Millstone Nuclear Power Station, Unit 3
NRC Chemical Engineering Branch (Fire Protection)
Review Meeting, March 28, 1984

Status of the NRC-CMEB (Fire Protection)
Draft SER Open Items Discussed at the Meeting
with the NRC-CMEB March 28, 1984

Responses to the Draft SER Open Items

sheet 1 of 2

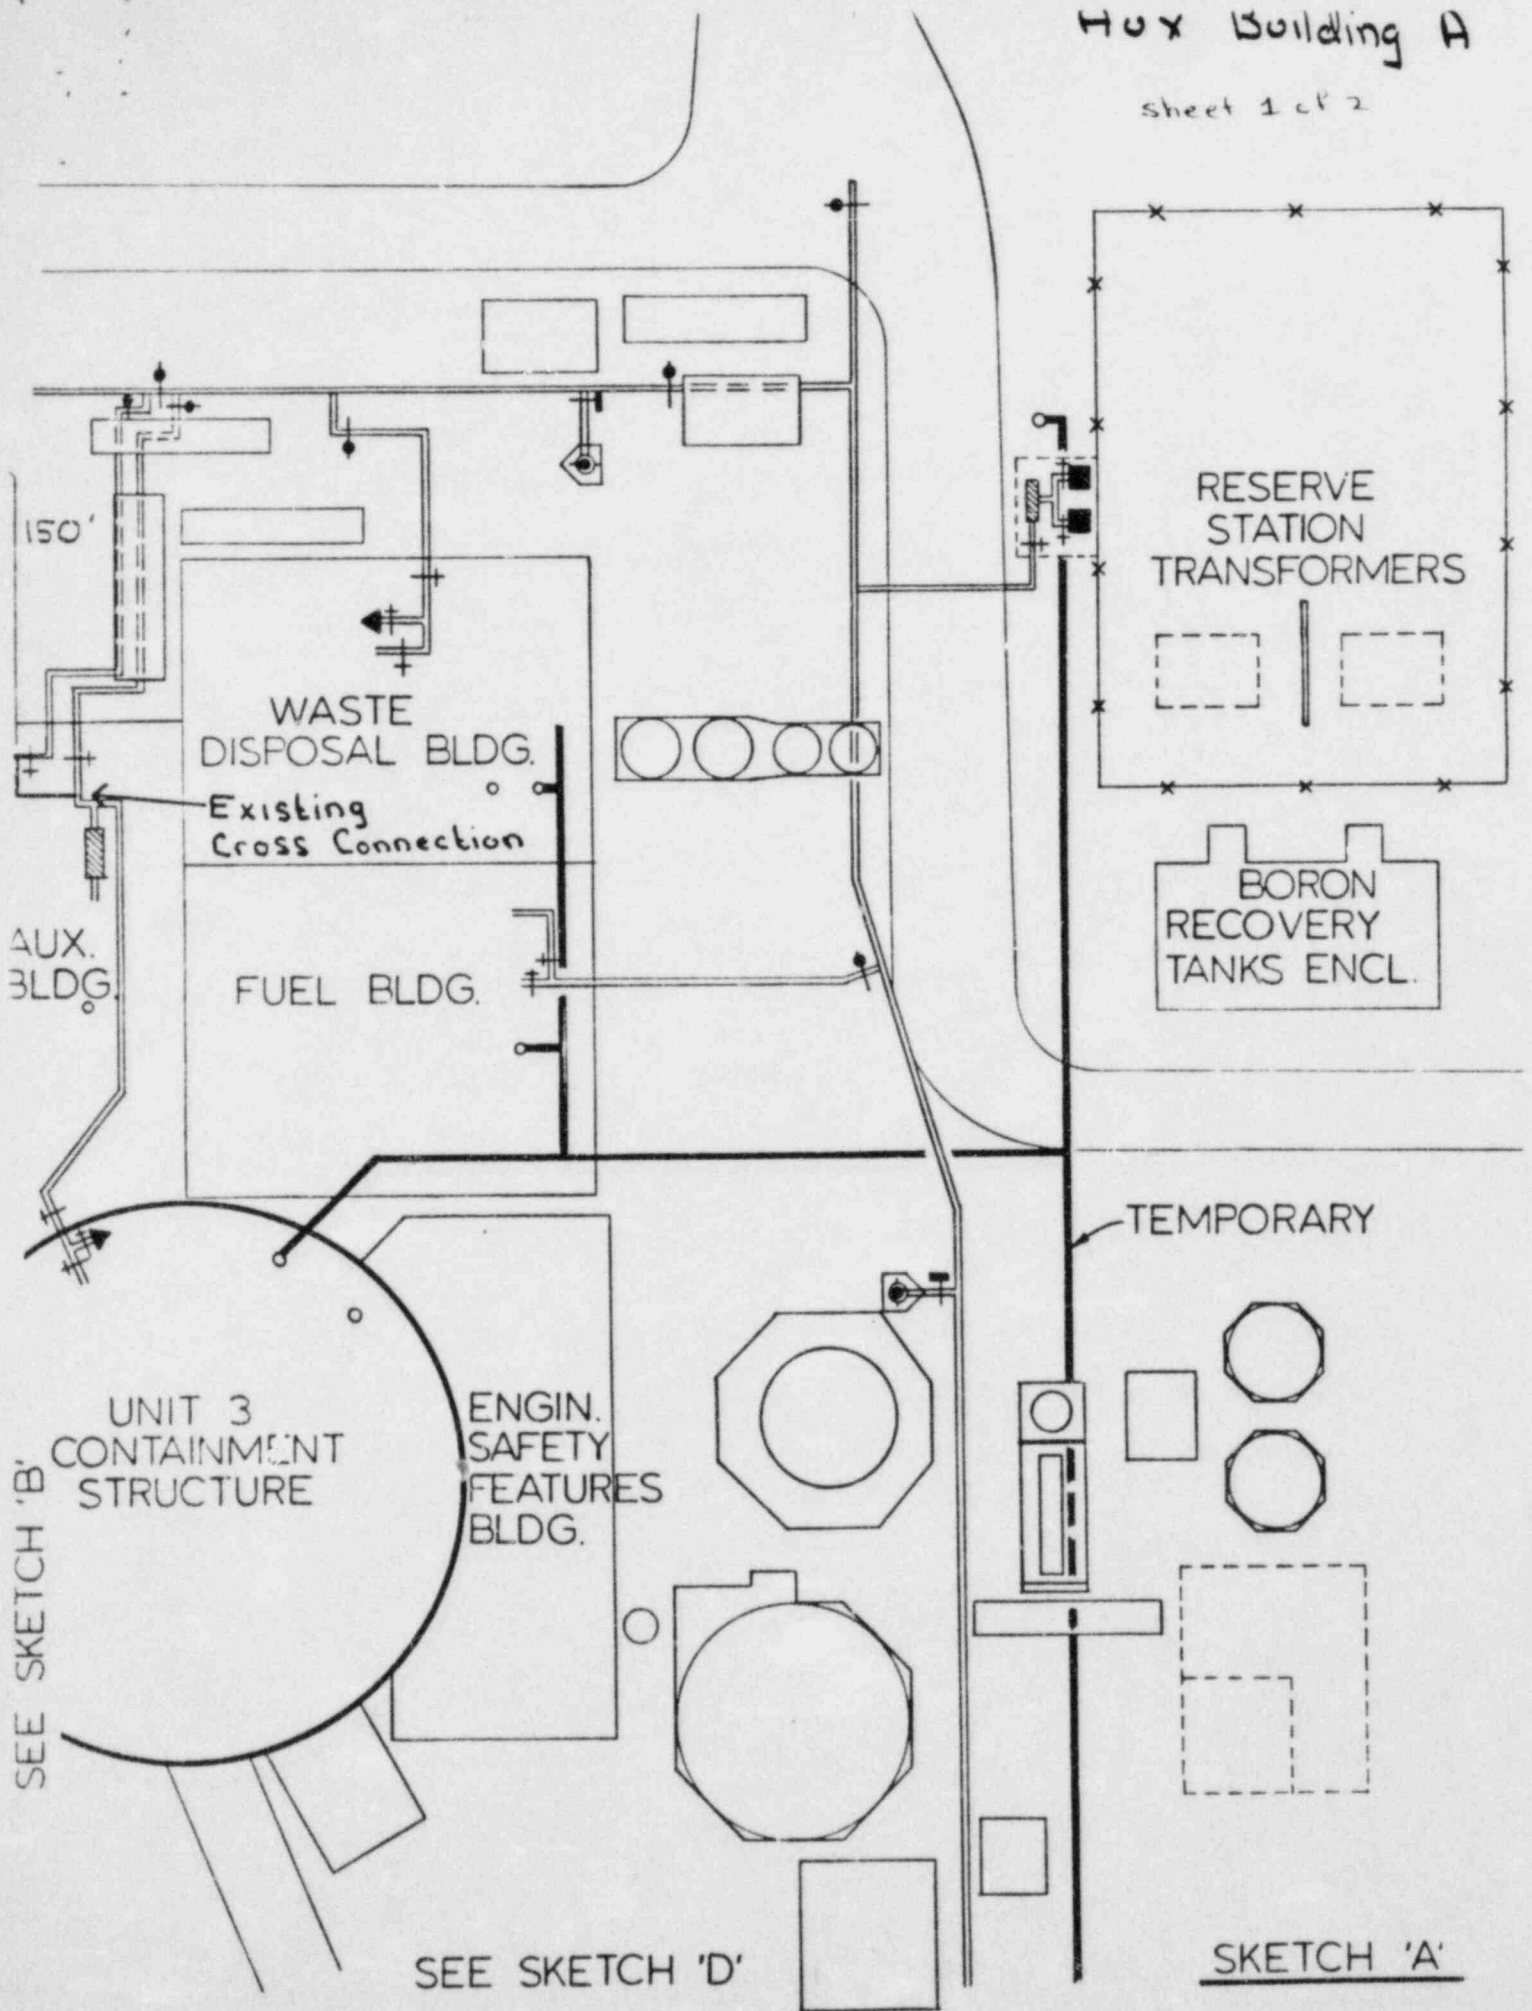
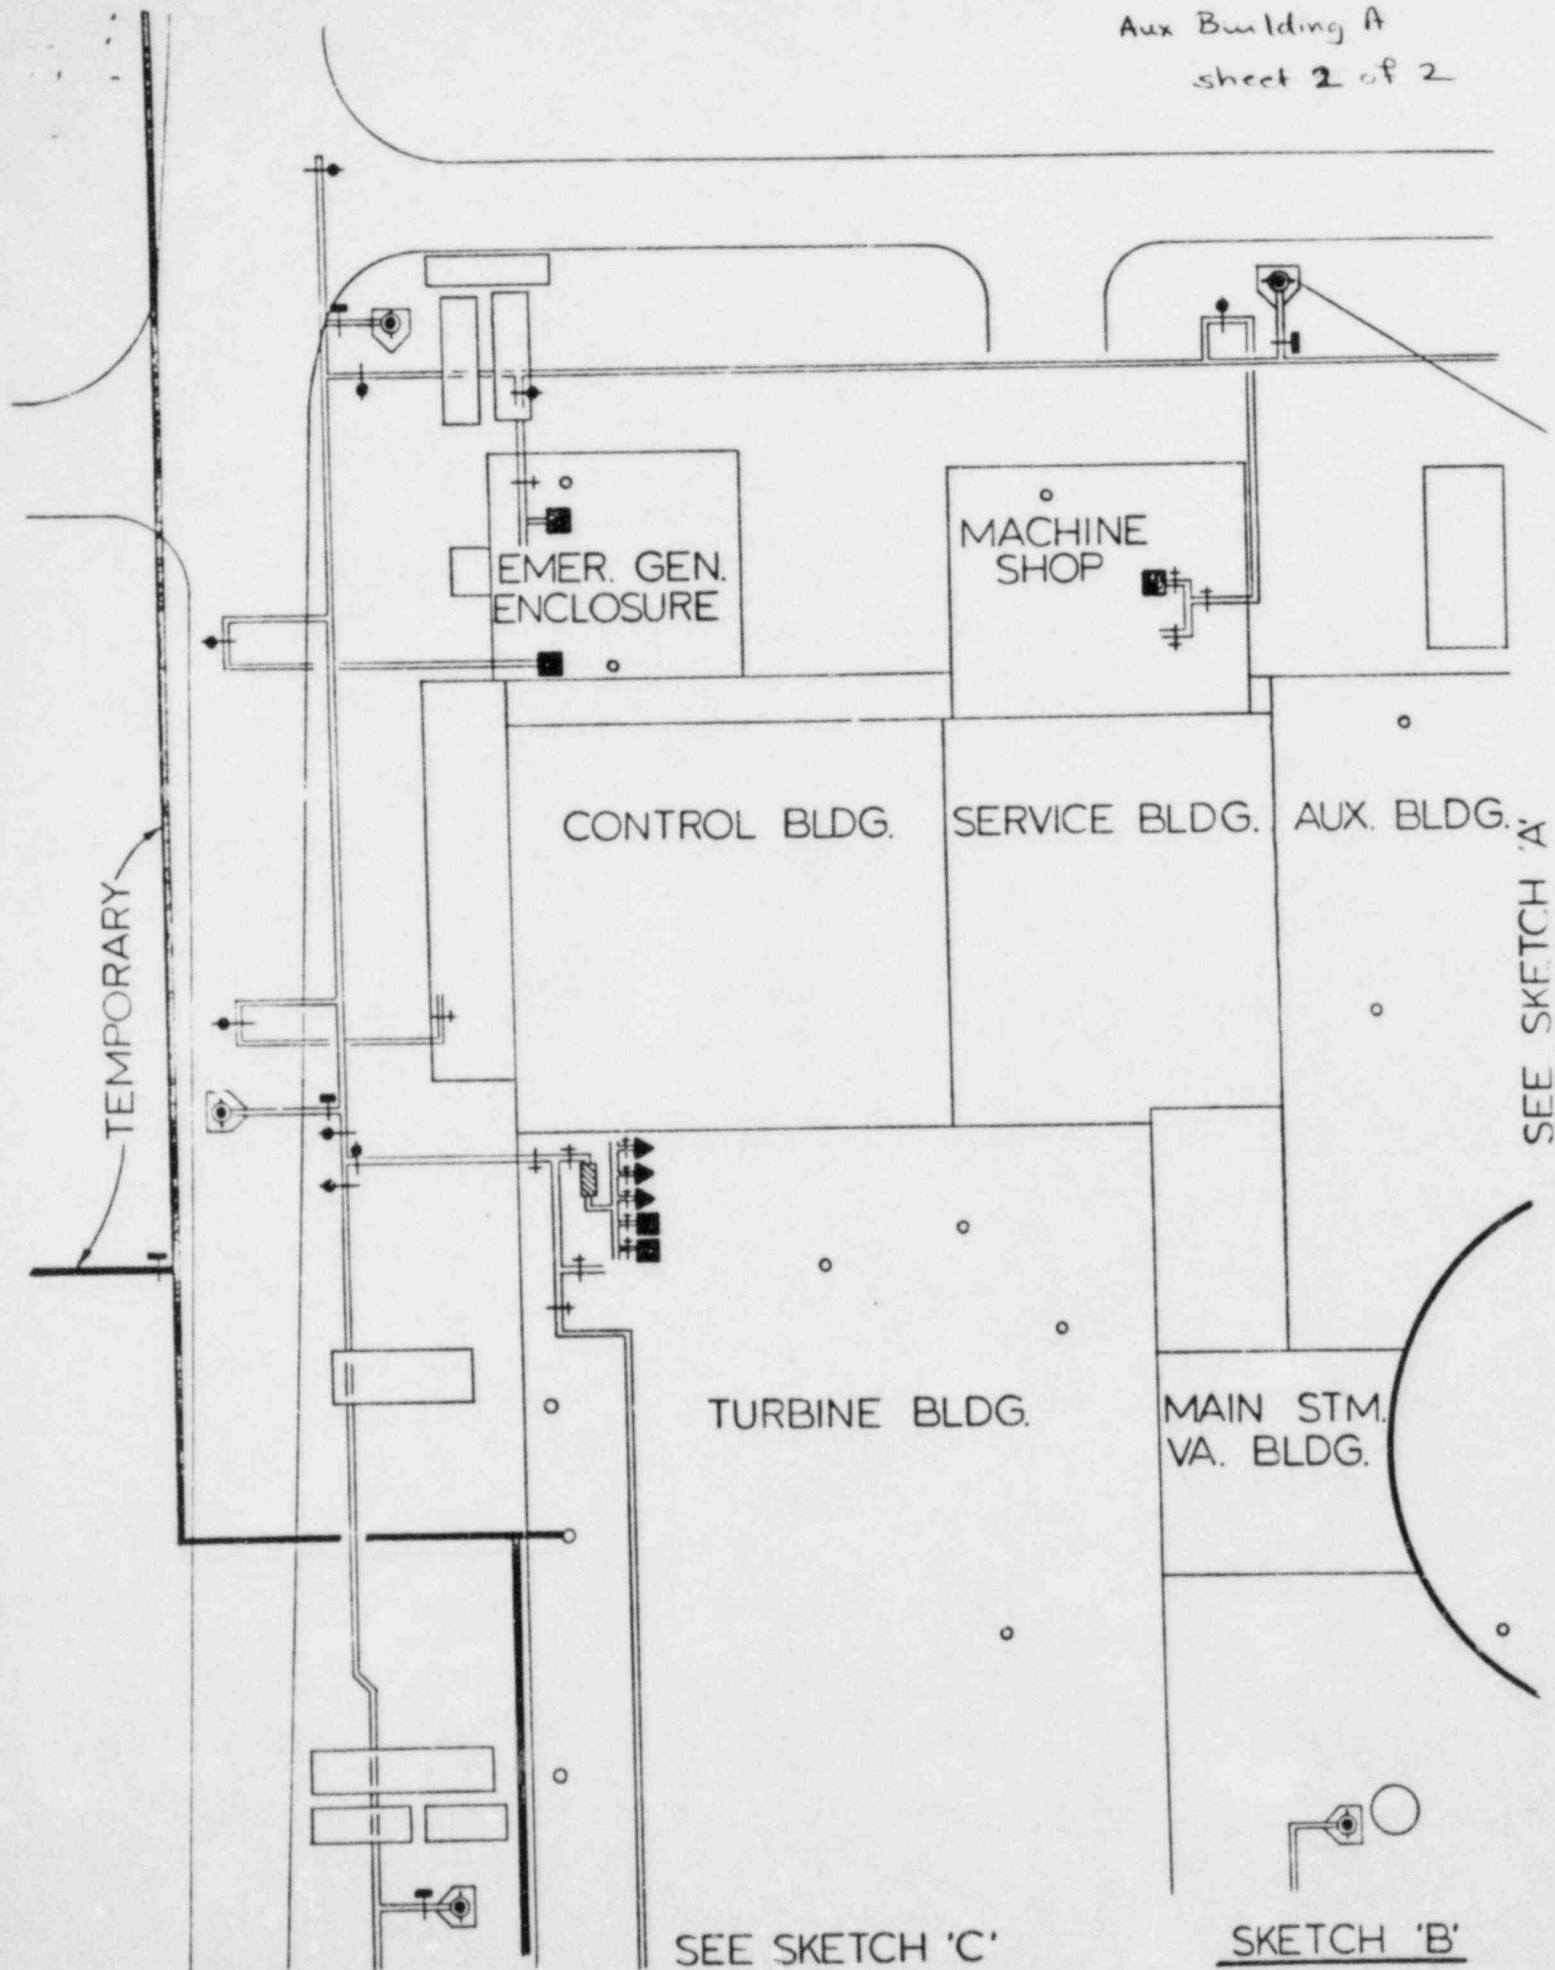
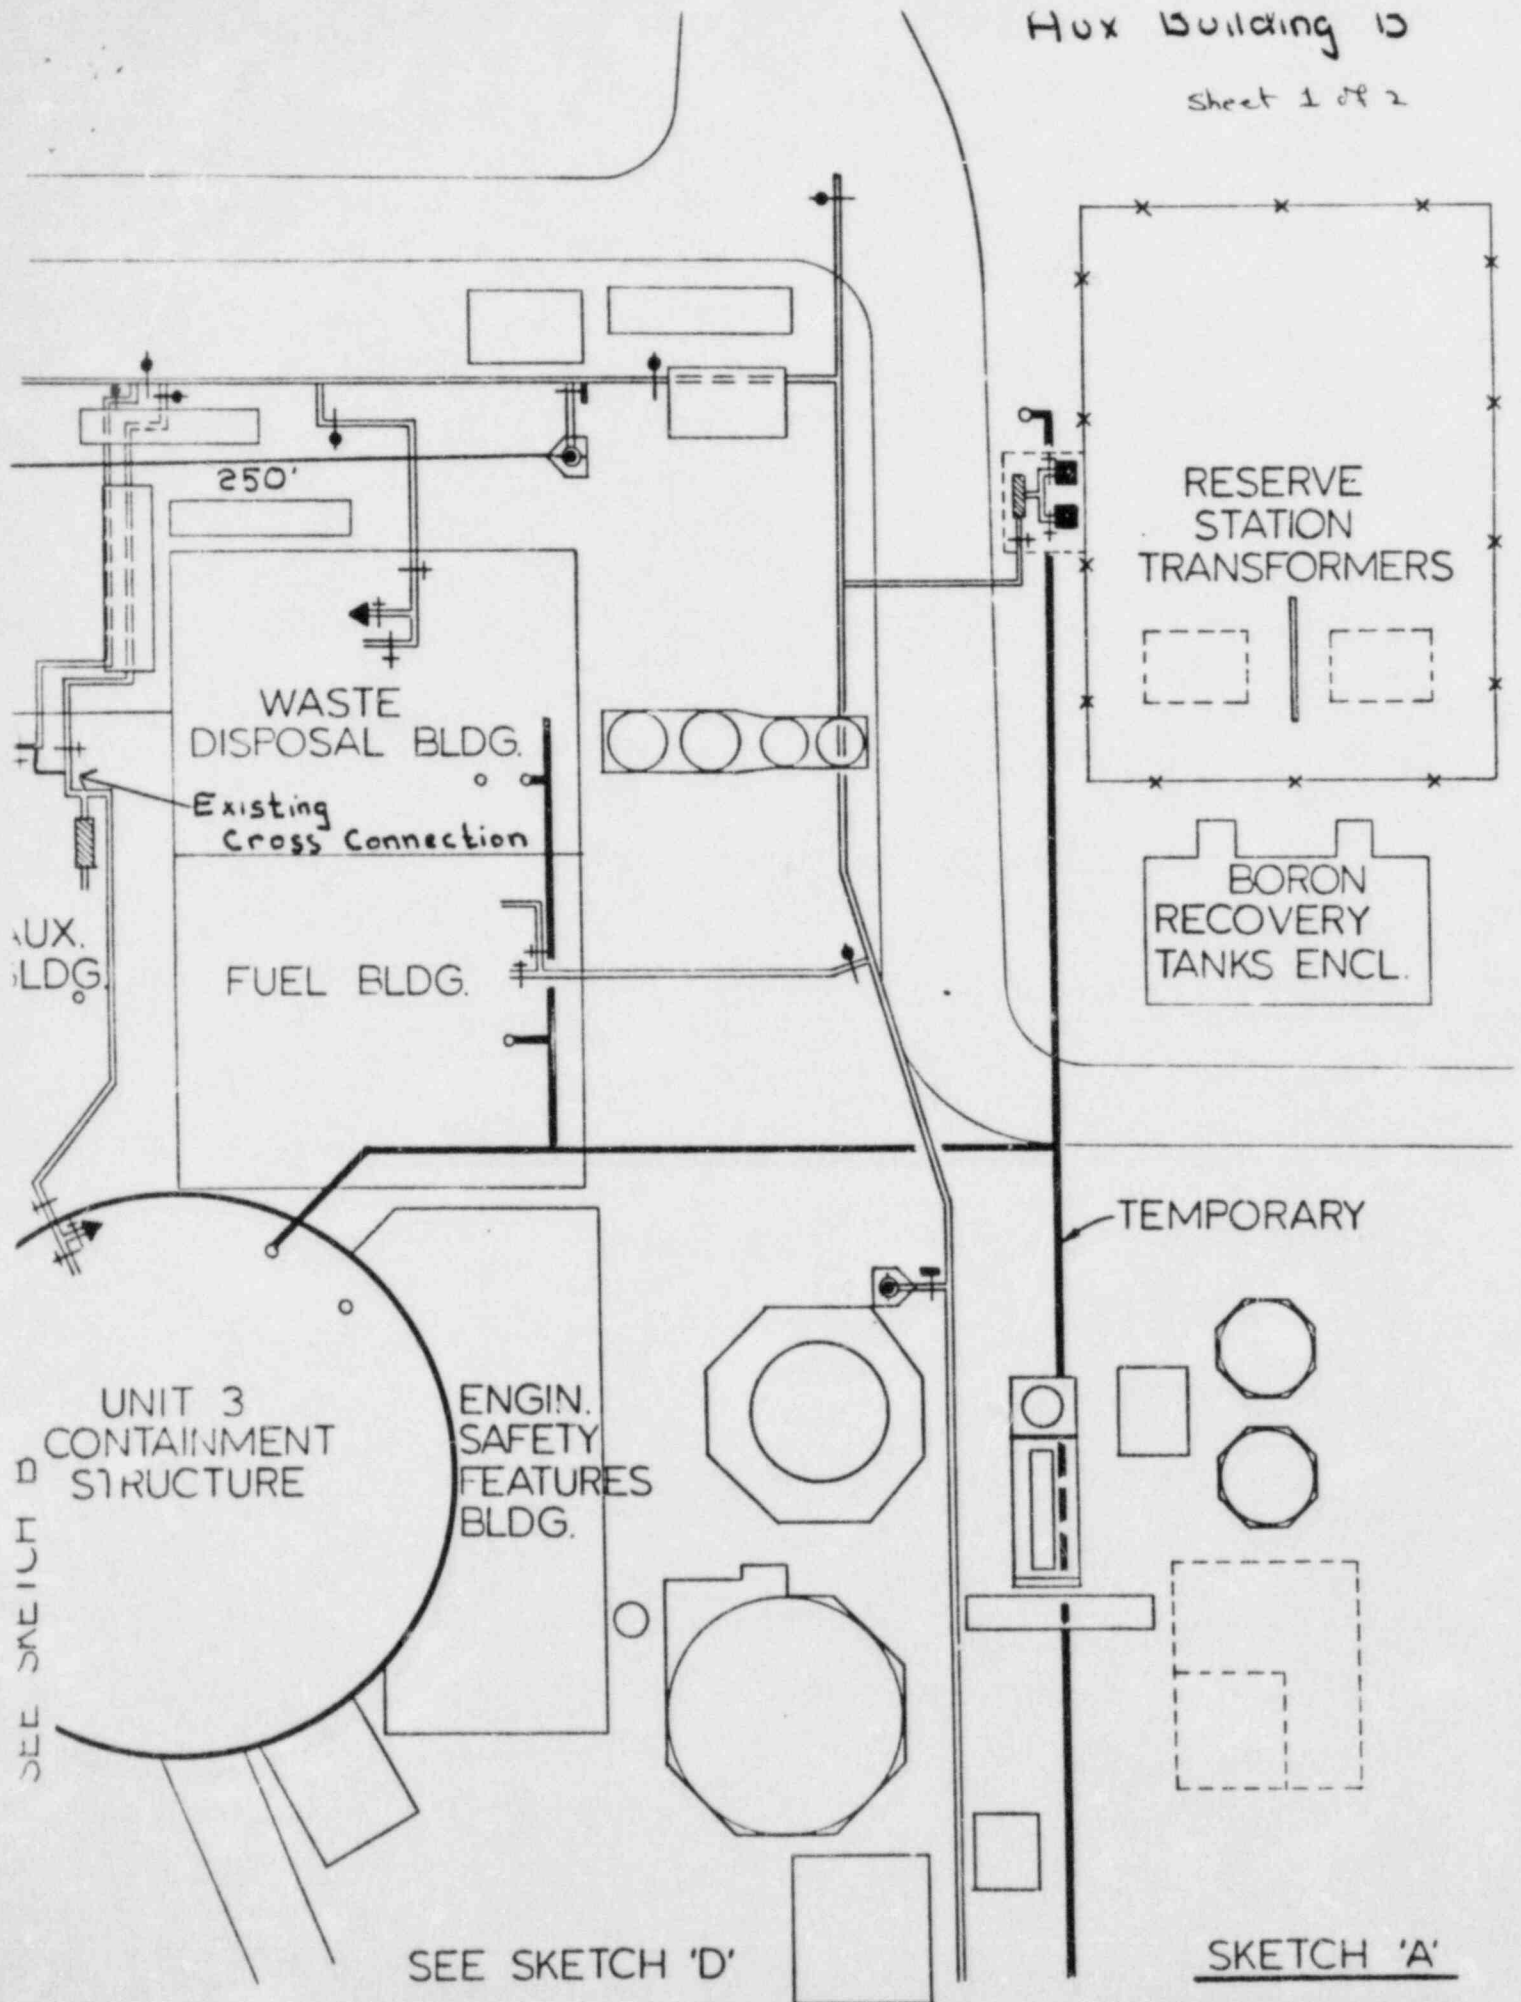
We will require the applicant to provide a fire protection water supply for the emergency generator enclosure, service building, waste disposal building, containment and the auxiliary boiler room such that a single break or failure in the supply piping will not result in the loss of both the primary and secondary water supplies. This is an open item.

The design of the underground fire water supply system at Millstone Unit No. 3, as illustrated on attached sketches A through D, is such that a minimum number of fire water suppression systems would be affected by a single break or failure. This same philosophy has also been utilized in the design of the plants interior fire water suppression systems. It is NNECO's concept should a break or failure occur in the fire water supply piping at Millstone Unit No. 3 to either:

- o Temporarily supply those fire water suppression systems rendered inoperable utilizing large diameter fire hose (2½ inch). Fire hose of sufficient quantity and size would be utilized to adequately supply the inoperable systems. These fire hoses would be supplied from fire hydrants connected to the underground fire water supply system that are unaffected by the break and/or failure. (See Table FP14-1).
- o Provide adequate manual fire suppression capability, in those areas affected by the pipe/break failure, by routing fire hoses from adjacent operable portions of the fire water system.

1. Those portions of the fire water supply piping highlighted in yellow are considered inoperable based upon a pipe break.
2. The primary temporary supply is the shortest route/discharge to an operable yard hydrant/water source.
3. The secondary temporary supply is the alternate source to the primary should it be unavailable.
